PRO 0071038
#3

April 17, 1996

Re: Responses to Soils Comments contained in your Soils - Technical Analysis for the Willow Creek Mine FAX of April 12, 1996.

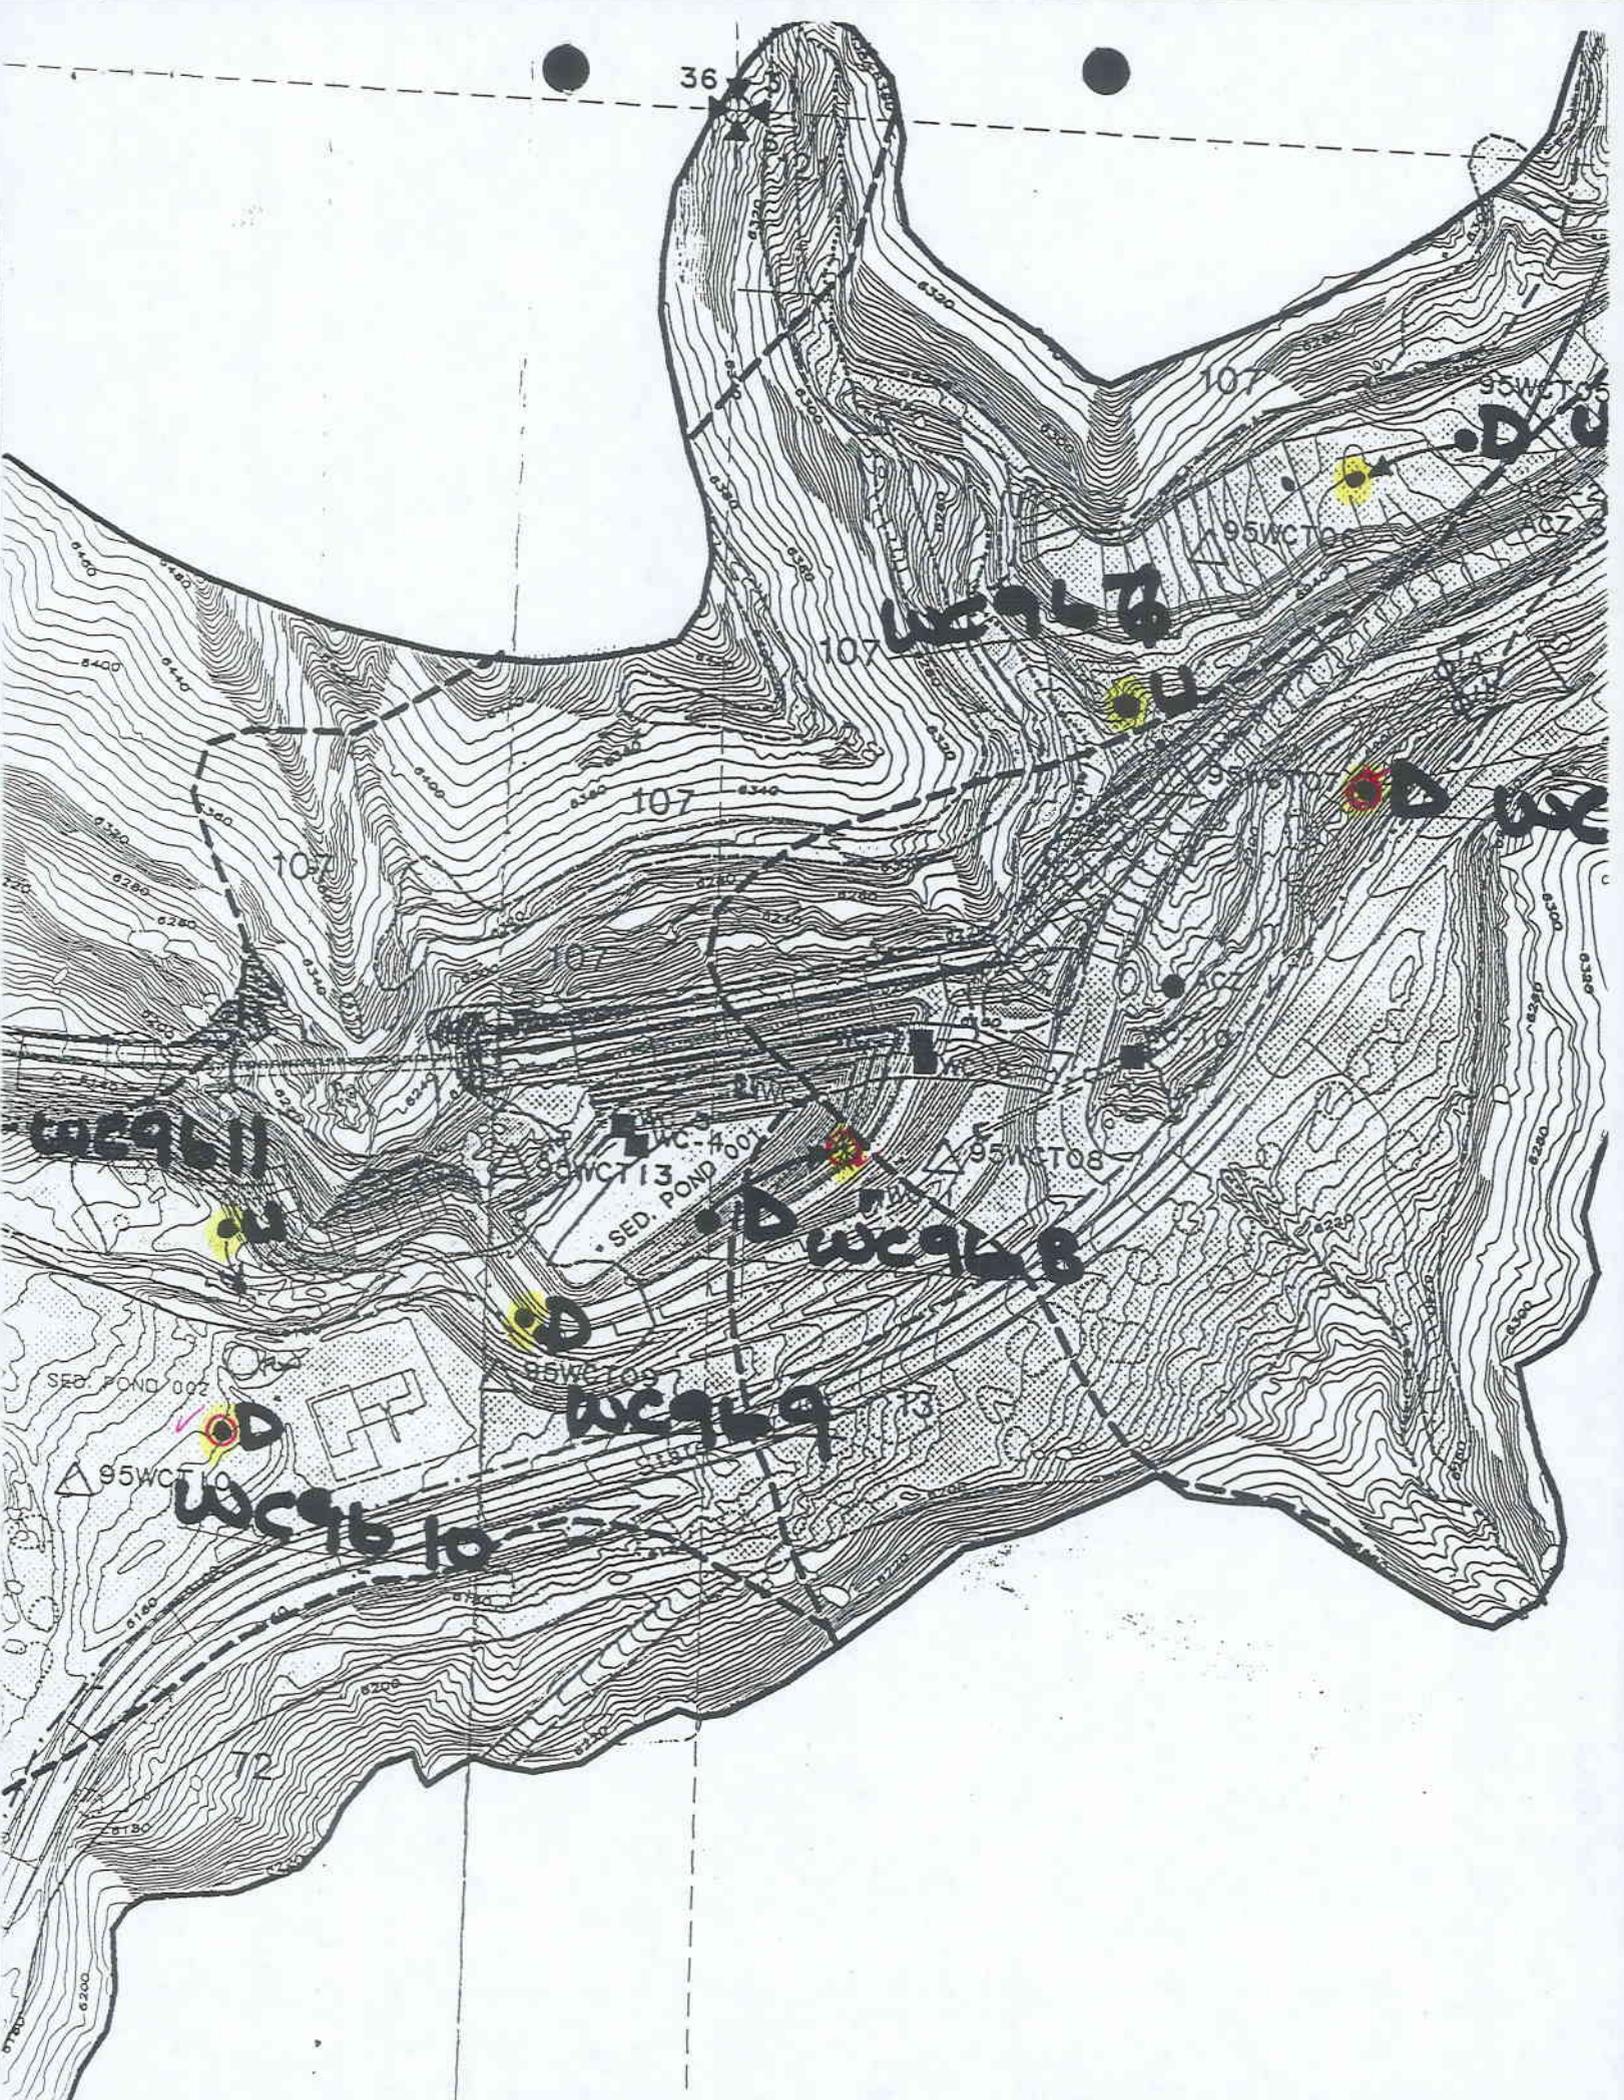
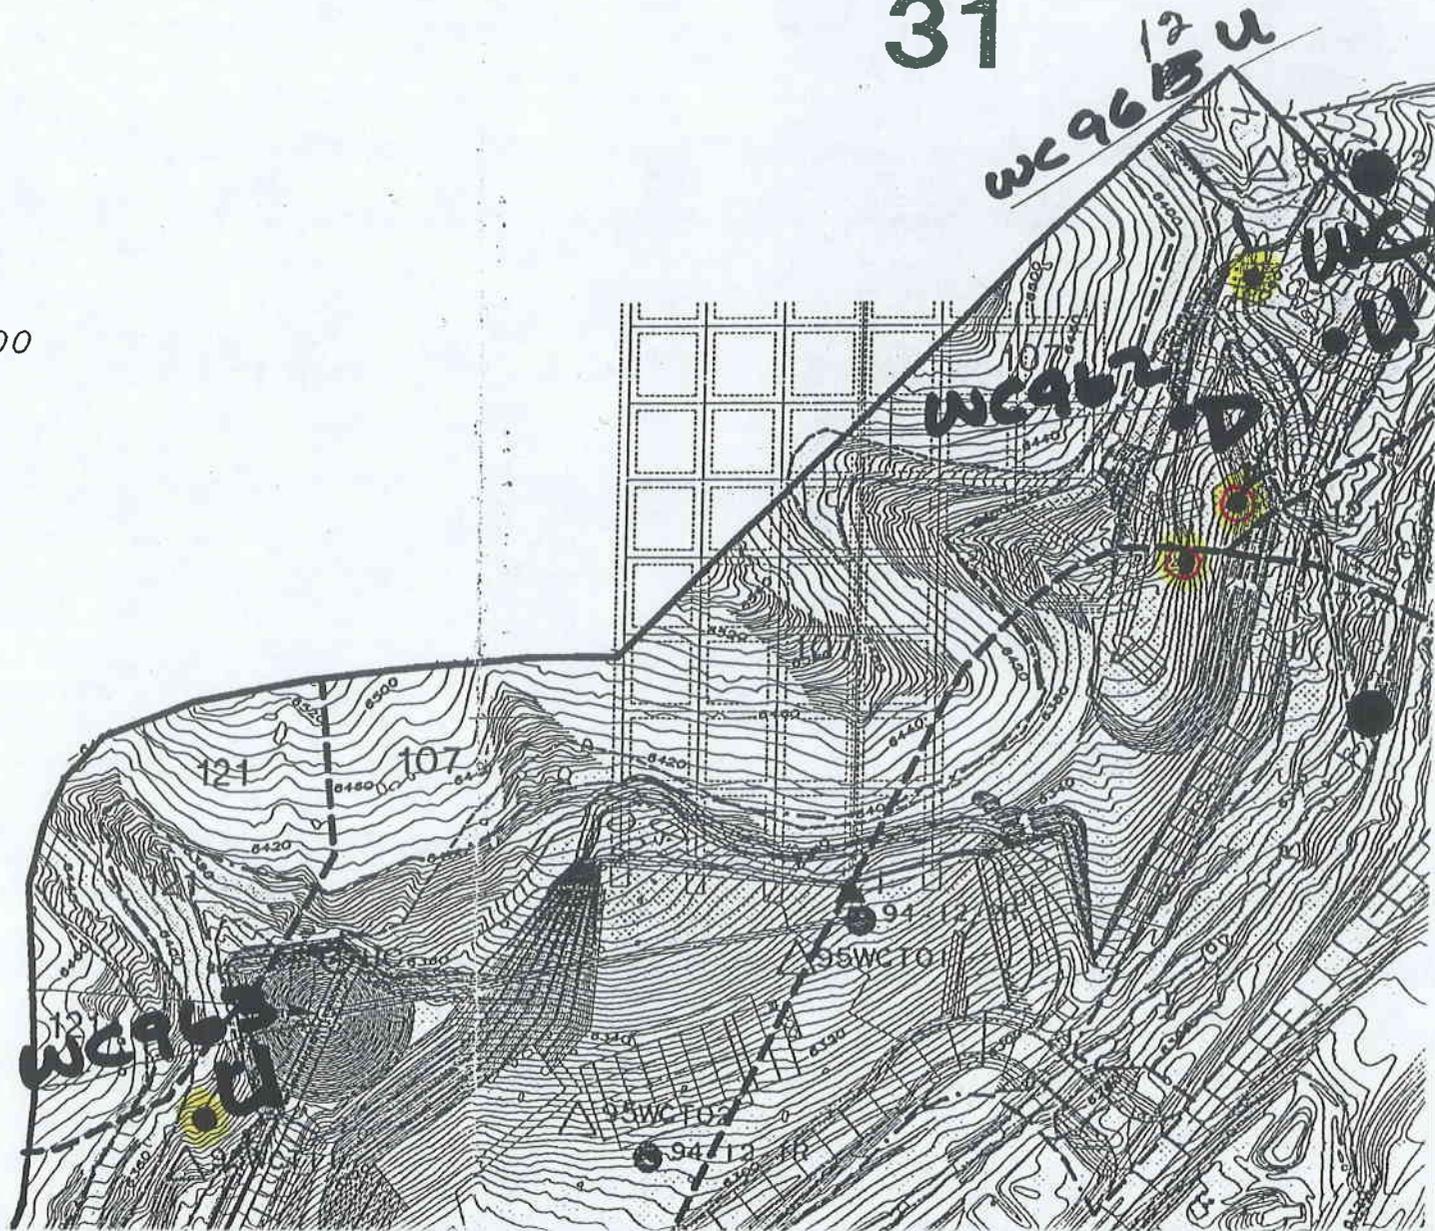
3. Update Map 4, Facilities Area Soils Map, to include 96 soil sampling pit locations.

7. **Make corrections to errors and inconsistencies within Section 3.1 and Map 4 as verbally discussed with Kent Crofts in April 1 st meeting. These corrections are outlined below:**

- **pp. 3.1-6, 1990 Sampling Program (CGCC).** Preparation Plant Sample sites 1-8 are referenced in text but can only find 6 sites on Map 4. Sites on Map 4 and Legend are given by ◊ #. The Legend simple states “Soil Sampling Site” and would be clearer if referenced as “1990 Soil Sampling sites.”

- **pp. 3.1-6, 1991 Soils Mapping (CGCC).** The text references Map 4 and reads at the end of paragraph as “Extent of the Castle Gate Soils Survey Area” but is actually shown on Map 4 as “Limits of Castle Gate Coal Co. Soils Survey Area.”

- **pp. 3.1-6, 1994 Soil Sampling Program (CPMC).** Twelve soil samples are referenced but can find 1, 3, 4, 5, 6, 7, and 10 on Map 4. Can’t find sites 2, 8, 9, 11 and 12 on

- **pp. 3.1-12, 1994 Soils Sampling Efforts section, 2 nd paragraph, line 4. Map 4 references given as “WC-1 through WC-12” and can’t find 2, 8, 9, 11, and 12. Again, text references “pits” and “1) soils profile descriptions...” when only grab samples were taken (see Exhibit 5).**

The locations of the 12 soils pits examined in the 1996 soils sampling effort are shown on the enclosed xerox pages of Map 4, Facilities Area Soils Map.

Response: We agree that the Map Legend would be more understandable if the sites labeled with a diamond ◊ # are labeled as “1990 Soil Sampling Sites” and this change will be made to Map 4

Response: CPMC recognizes that the terminology in these two statements might be interpreted as being slightly inconsistent. Therefore, the Legend on Map 4 will be revised to read “Extent of Castle Gate Soils Survey Area.”

Response: The Division is correct that 1994 soils sample sites 2, 8, 9, 11 and 12 can not be found on Map 4. These sample locations were originally placed on the Map but were removed in subsequent modifications. They have been added to the Map. Soils Pit WC-2 is located to the east of the existing office trailer in the AML reclaimed site near the southern end of Stream Realignment Section # 2, Soils Pits 8 and 9 are located immediately to the west of the existing culverted crossing of Willow Creek while samples WC-11 and 12 are located approximately 150 feet upstream of this culvert.

Response: The locations of samples WC-2, 8, 9, 11 and 12 have been added to revised
